Submission on PDP Presentation to Hearing 3

Paul Botha 7 December 2021

Submitter number 118

Flood Hazard zones included in PDP.

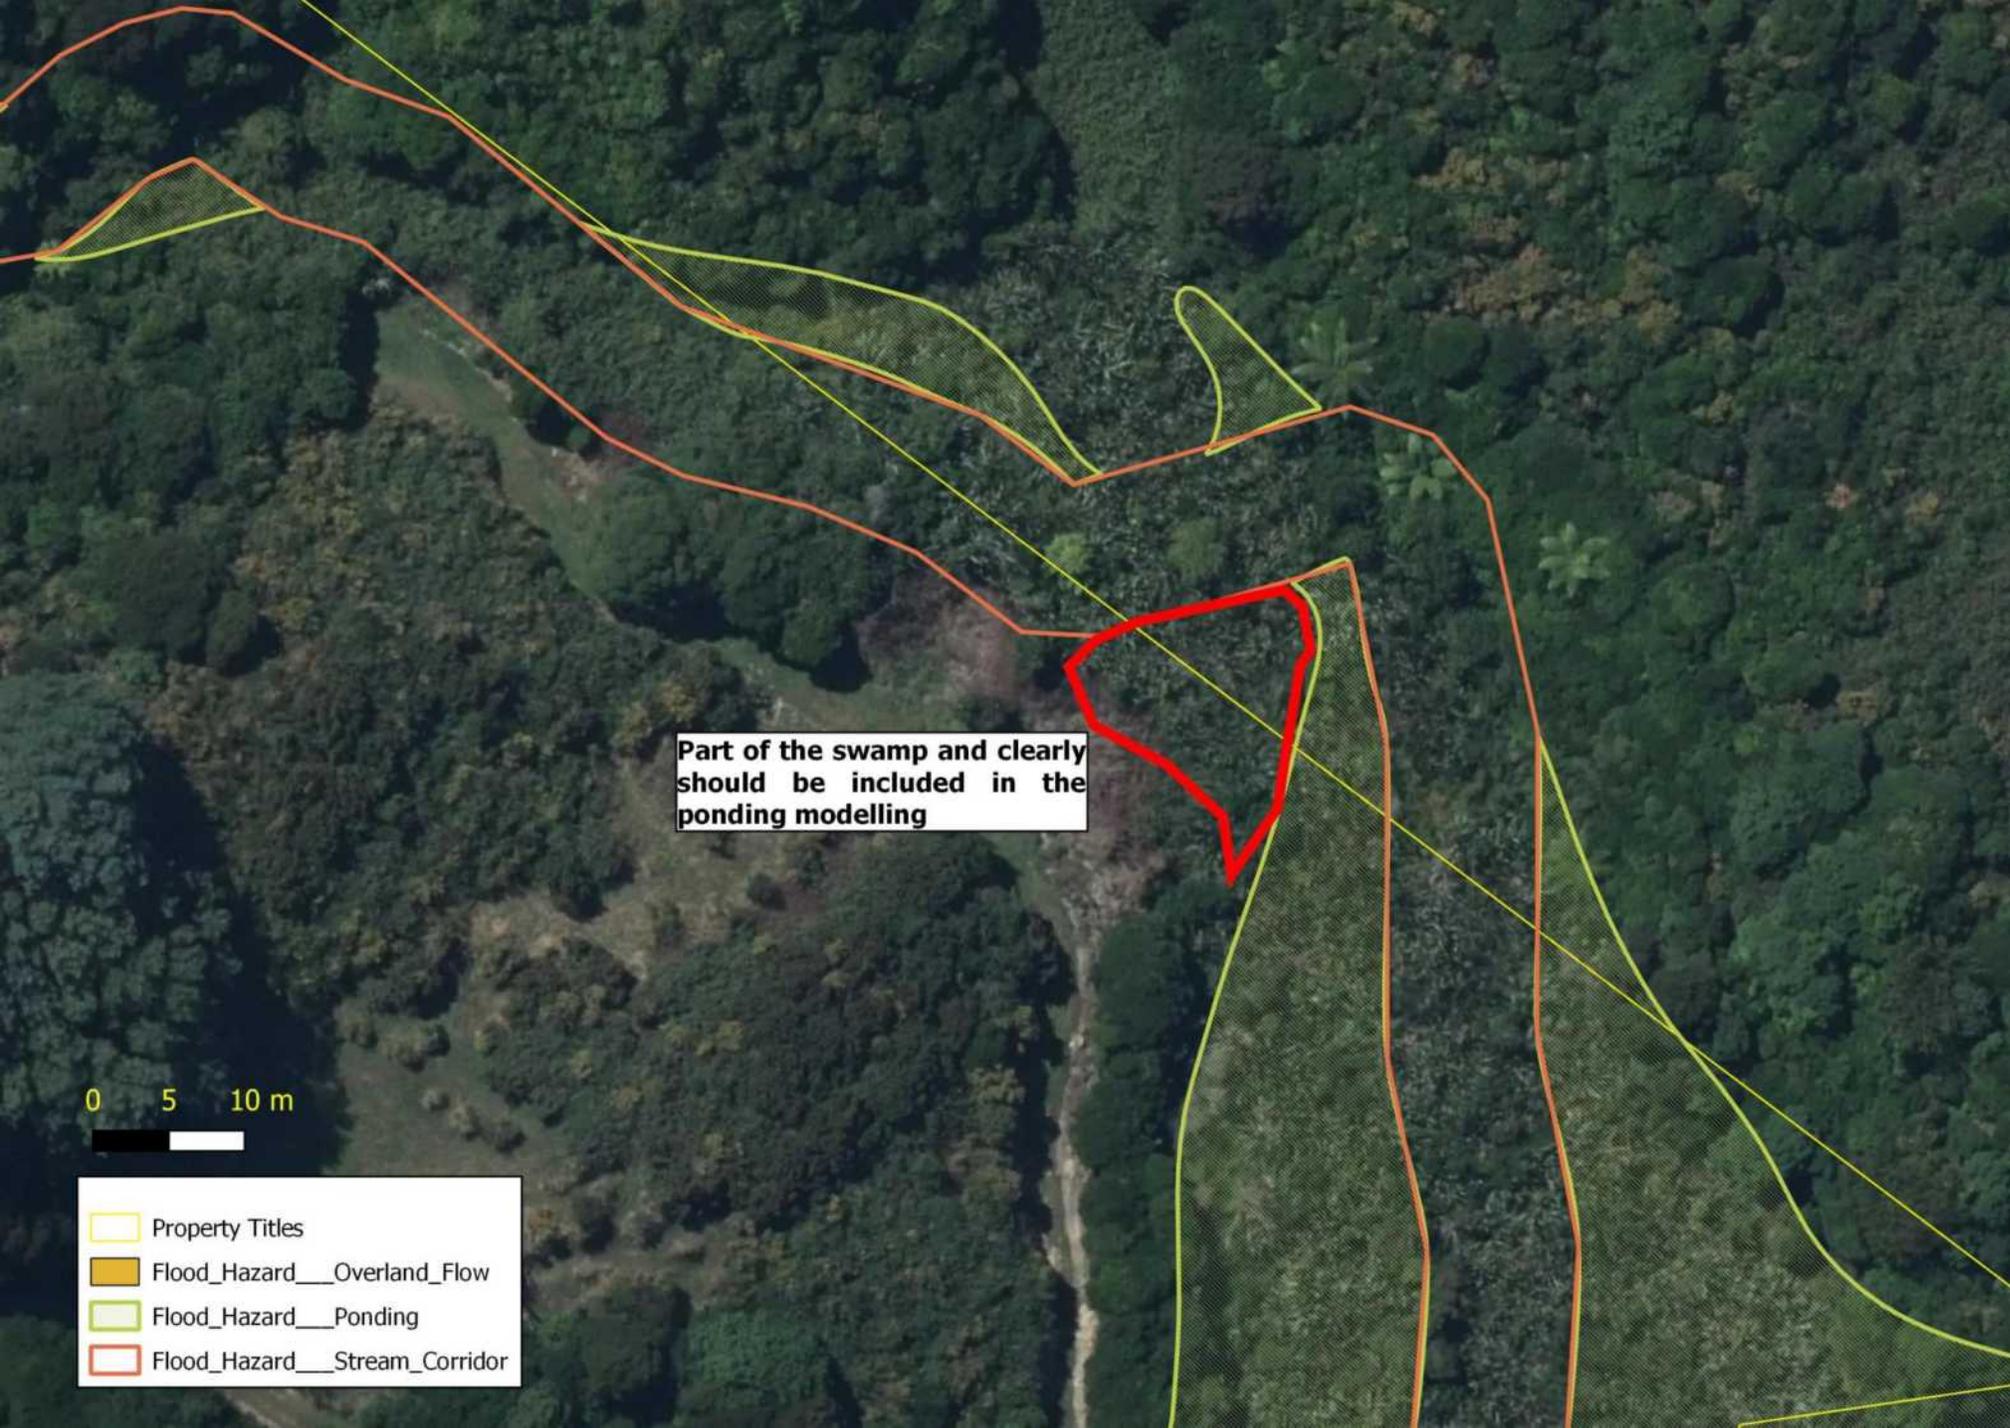
- Map shown to give reference to the enlargement shown on the next slide, which I believe demonstrates the accuracy issue with the ground elevation model and subsequent flood modelling.
